| KEYSTONE ELECTRONICS CORP. | | | | |
|---|--|--|--|--|
| CERAMIC STANDOFF | | | | |
| DECIMAL ± .005 [± 0.13] ANGULAR ± 1° C | 7712 | | | |

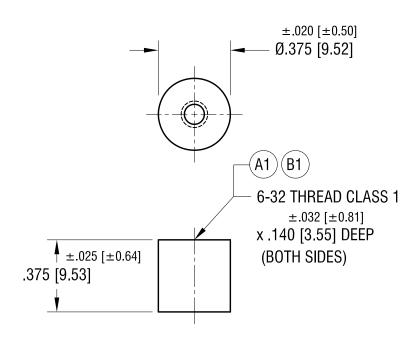
| 3.30.22 | B1 WAS .140±.015 DEEP CHANGE AS PER ECN 22-063 | В |
| 3.11.22 | HOLE DEPTH (A1) WAS .156 CHANGE AS PER ECN 22-057 | Α |
